PROJECT NAME: SW 100TH STREET PUD - WEST

PROJECT NUMBER: 2022070105

APPLICATION: IMPROVEMENT PLAN #29965

Sheet No.
C001
of
C022

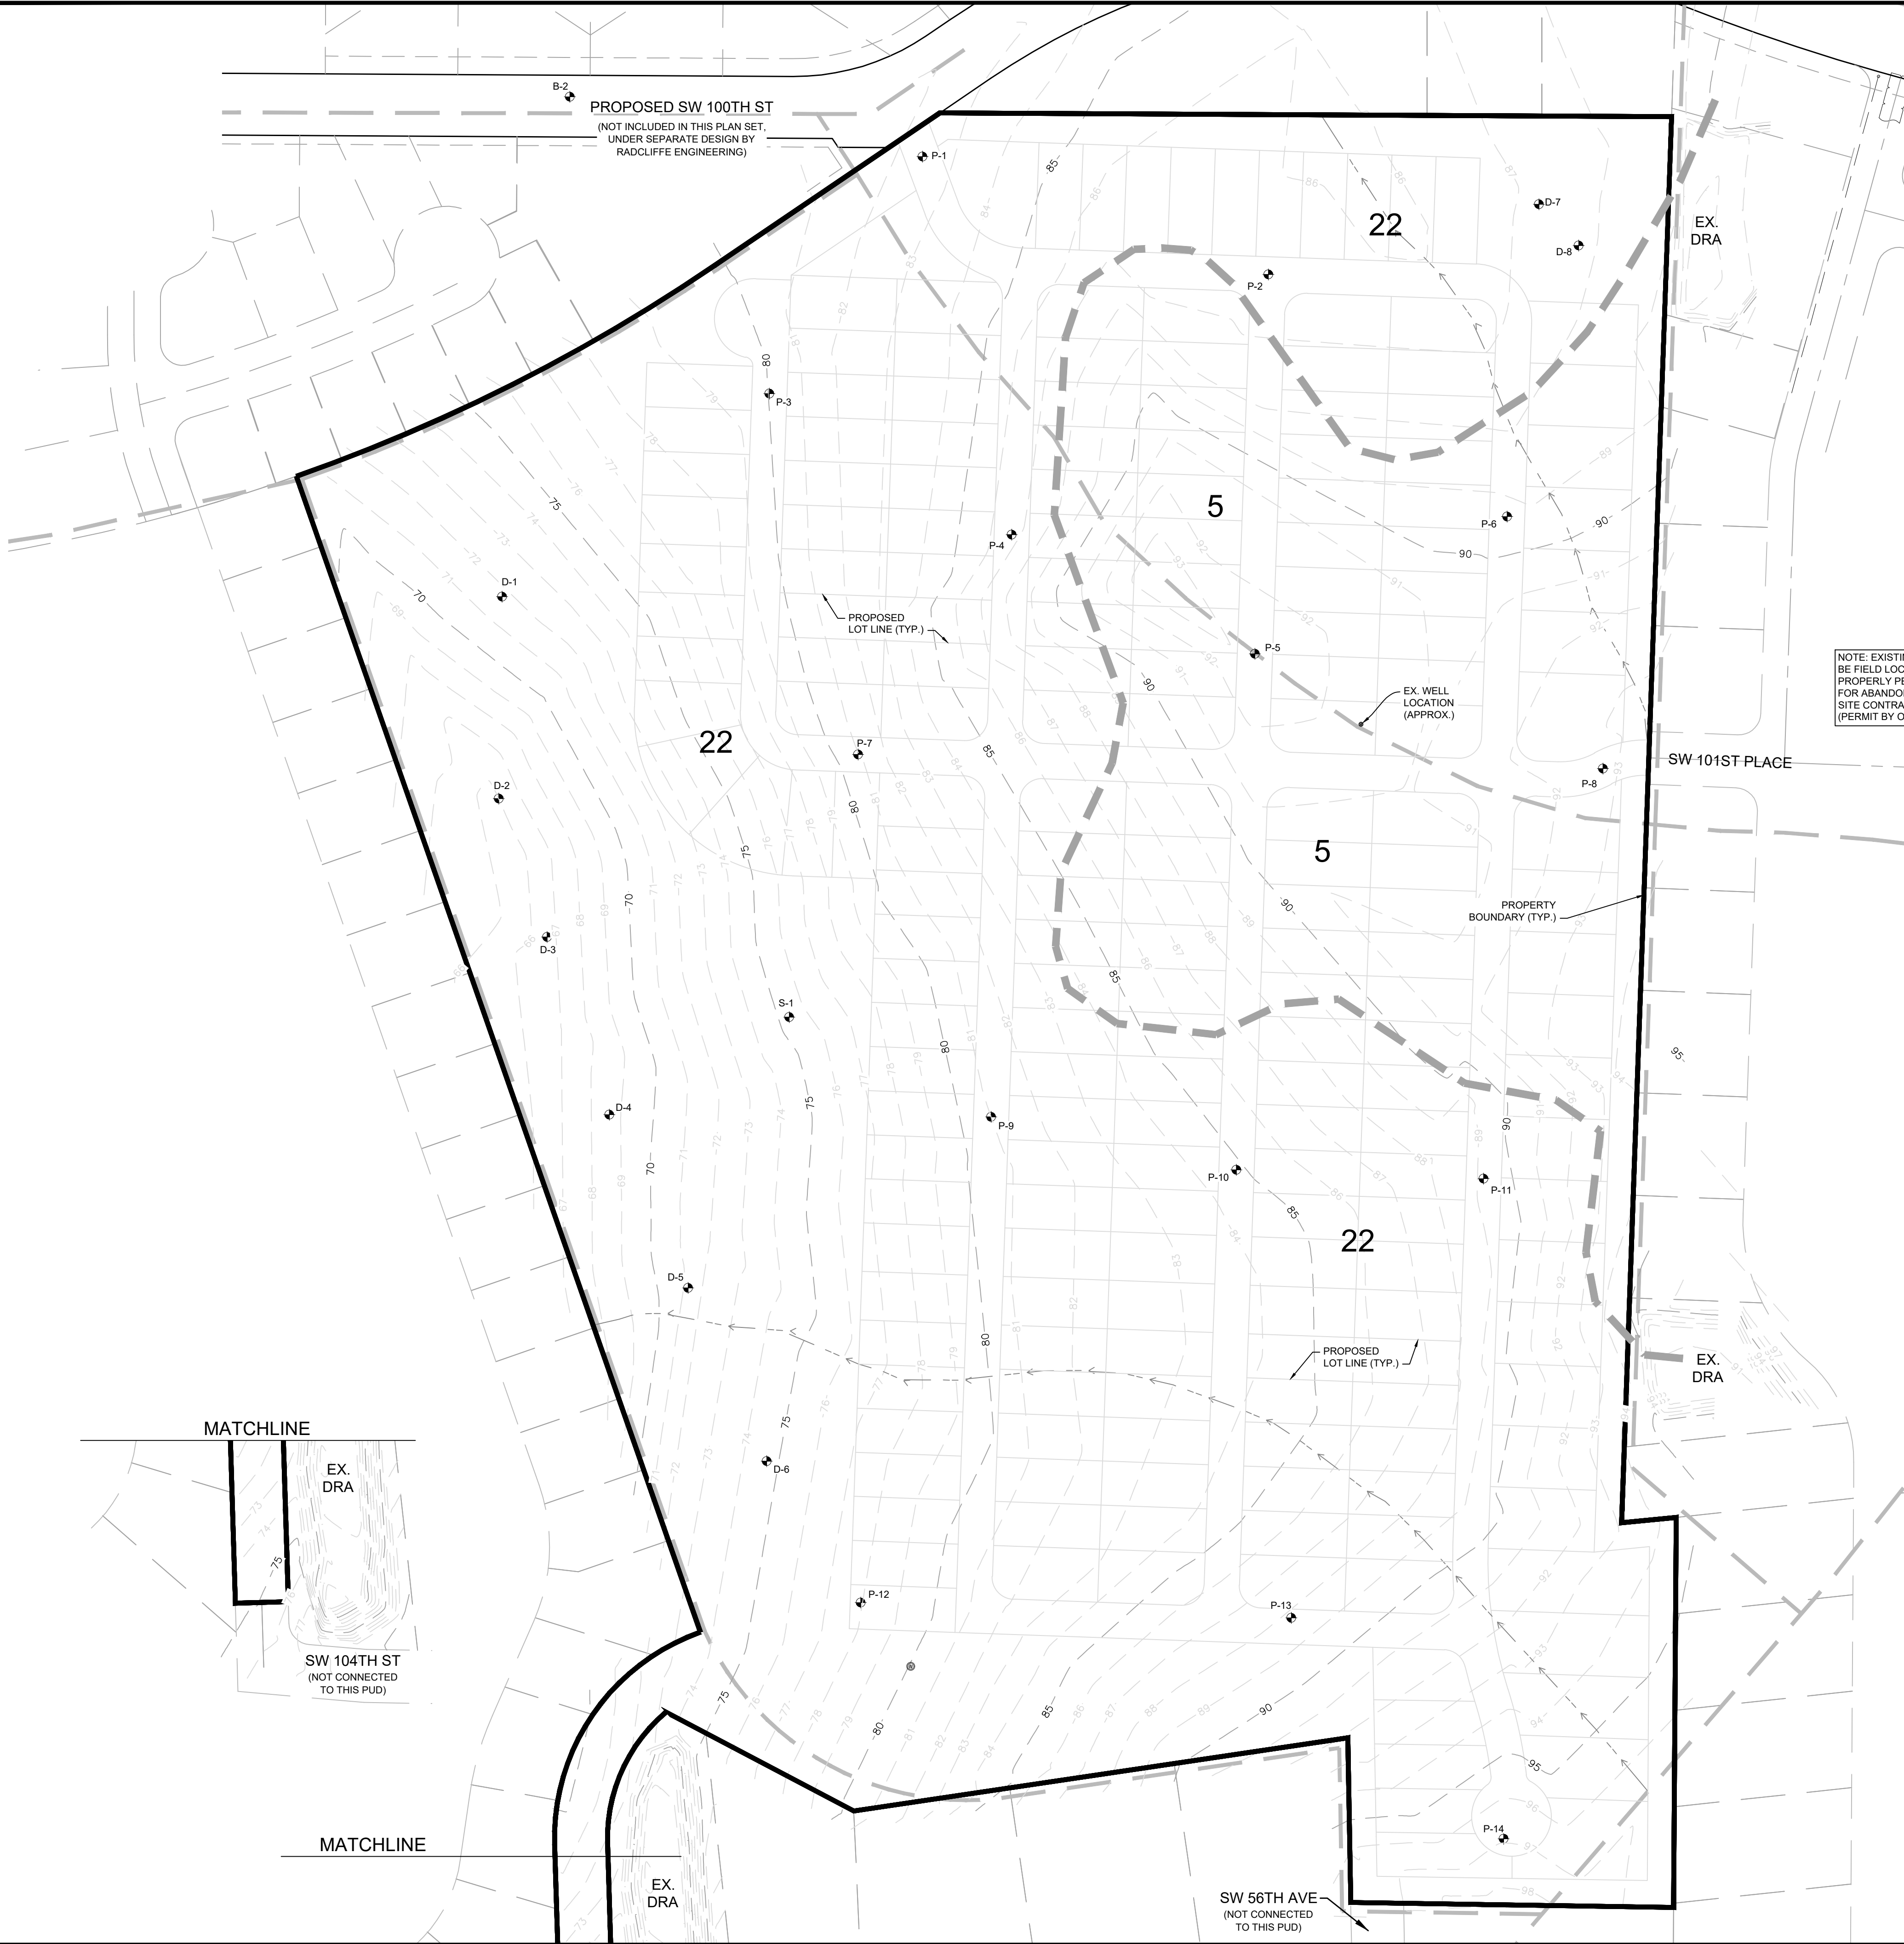
- 10 DEPARTMENT: 911 - 911 MANAGEMENT
REVIEW ITEM: Additional 911 comments
STATUS OF REVIEW: INFO
REMARKS: On AR 29965 (Improvement Plan) Sheet C001 shows 204 Single Family Lots under Site Information and on AR 29089 (Preliminary Plat) Sheet C001 shows 203 Single Family Lots under Site Information. The Site Layouts in both plans have Block C showing 21 lots but other sheets are showing 20 lots. The lot to the North of Block C Lots 1&2 needs to be labeled a lot or a tract on all applicable sheets in both plans. When the finals are submitted the lot mentioned above needs to be labeled and the number of single family lots will need to match on all plans to avoid the plats being rejected for this.

Sheet No.
C007
of
C022

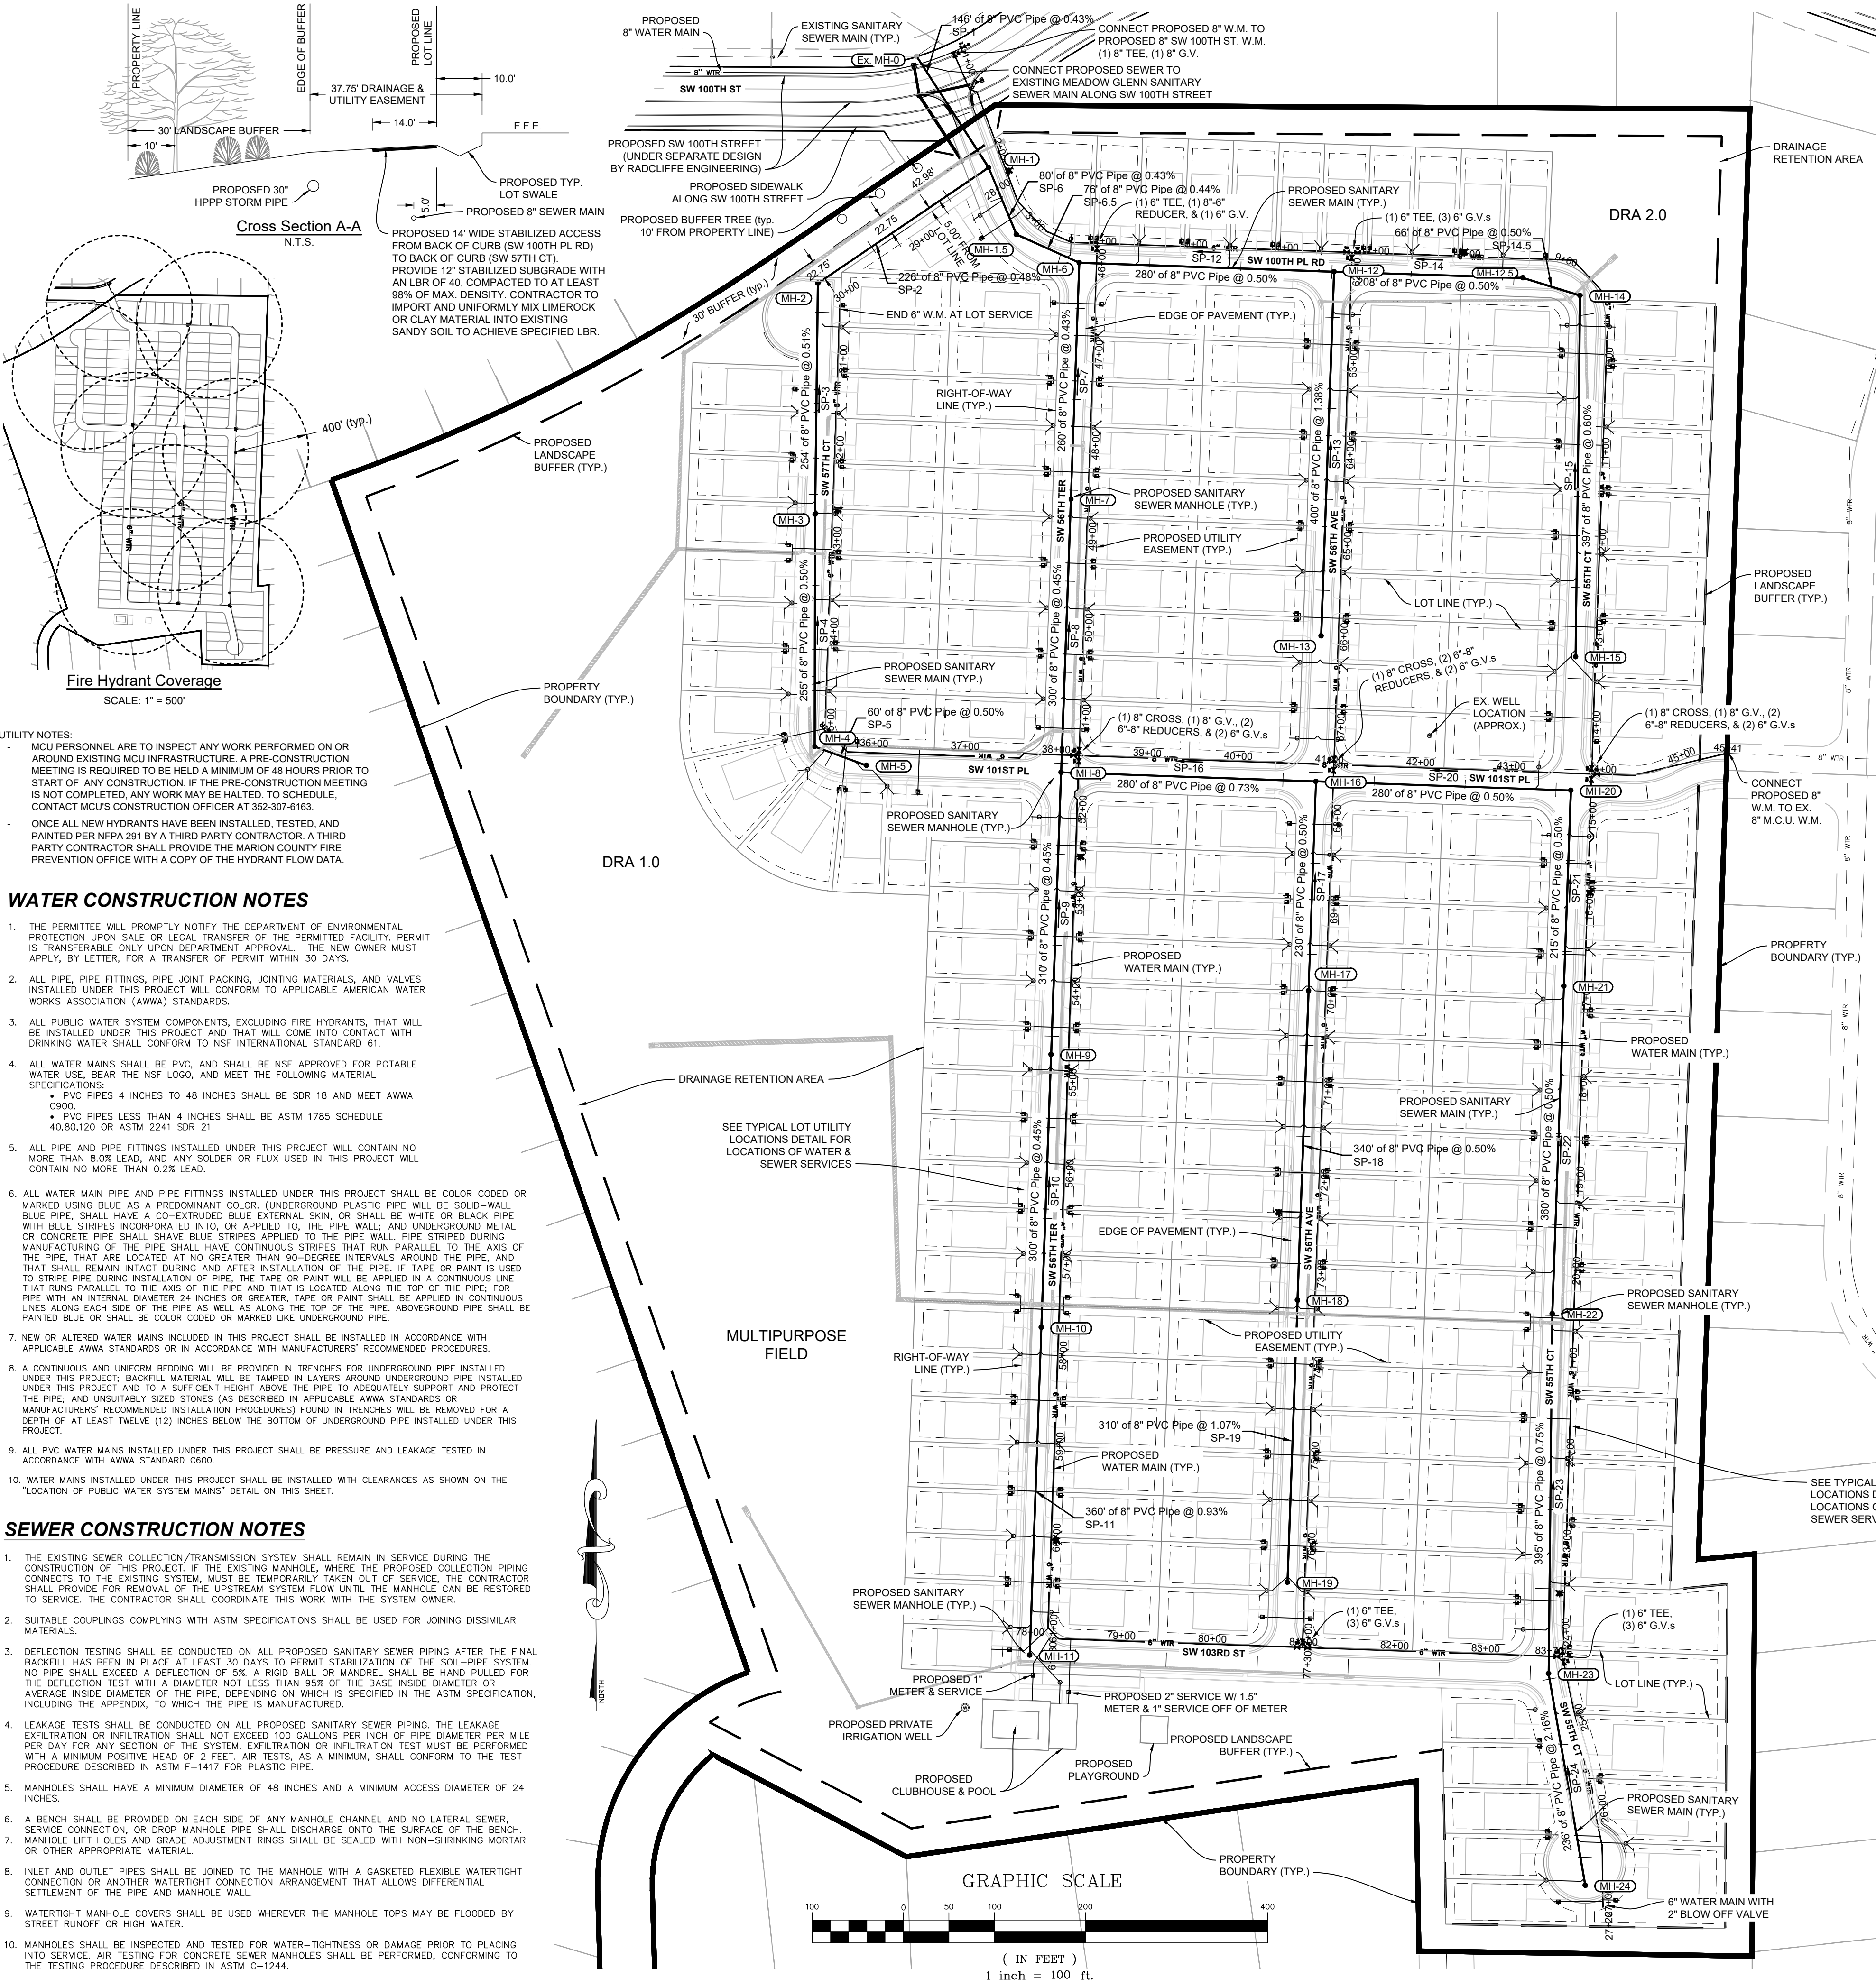
- 11 DEPARTMENT: LSCAPE - LANDSCAPE DESIGN AND IRRIGATION
REVIEW ITEM: 6.7.9 - Replacement trees; general requirements
STATUS OF REVIEW: INFO
REMARKS: Existing trees to remain = 7,259" which meets the 100" per acre requirement. Please clarify calculations for additional tree inches.
